Access Compliance Report Public Rights-of-Way (Curb Ramps)

Intersection ID: 10090	Main Street: ROSLYN_AV	Cross Street: S_TURNER_AV	Location: S
ADA ID: C9A9A41D178B	Ramp Type: Perp	Initial Pass/Fail: Fail	Overall Compliance: No Severity Score: 8.75

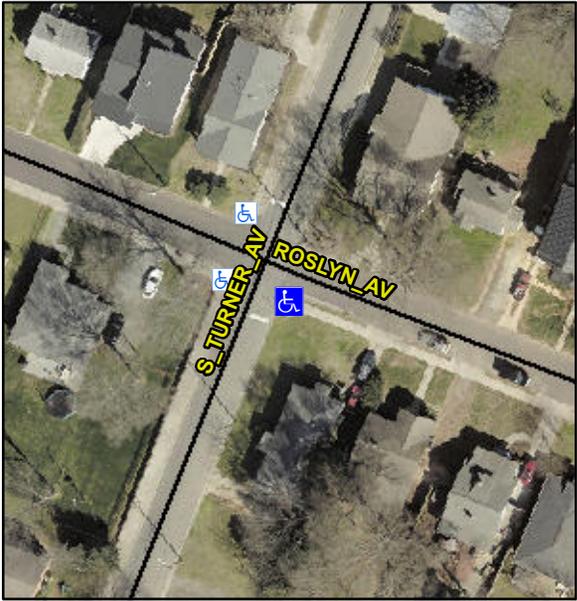
Possible Solutions:
Remove & Replace Entire Ramp.

PROW/ADA:
Not Found, R304.5.1

Compliance	Description	Data	Compliance	Description	Data
N/A	Ramp Length (in)	86.0	Yes	Ramp Slope (%)	5.0
No	Ramp Width (in)	45.5	Yes	Ramp XSlope (%)	1.2
N/A	Flare Type LT	N/A	N/A	Flare Type RT	N/A
N/A	Flare Slope LT (%)	N/A	N/A	Flare Slope RT (%)	N/A
N/A	Flare Traversable LT?	N/A	N/A	Flare Traversable RT?	N/A
N/A	Landing Length (in)	N/A	N/A	DWS Provided?	N/A
N/A	Landing Width (in)	N/A	N/A	DWS Contrast?	N/A
N/A	Landing Slope (%)	N/A	N/A	DWS Length (in)	N/A
N/A	Landing X Slope (%)	N/A	N/A	DWS Full Width?	N/A
N/A	Landing Curb? (Y/N)	N/A	N/A	DWS Offset (in)	N/A
N/A	Shared Landing?	N/A			
N/A	Gutter Ponding?	N/A	N/A	Gutter Slope (%)	N/A
N/A	Gutter Lip Ht (in)	N/A	N/A	Gutter X Slope (%)	N/A
N/A	Painted X Walk1?	No	N/A	Painted X Walk2?	N/A
	X Walk 1 Direction	To NW		X Walk 2 Direction	N/A
N/A	X Walk 1 Width (in)	N/A	N/A	X Walk 2 Width (in)	N/A
	X Walk 1 Slope (%)	0.1		X Walk 2 Slope (%)	N/A
	X Walk 1 X Slope (%)	1.5		X Walk 2 X Slope (%)	N/A
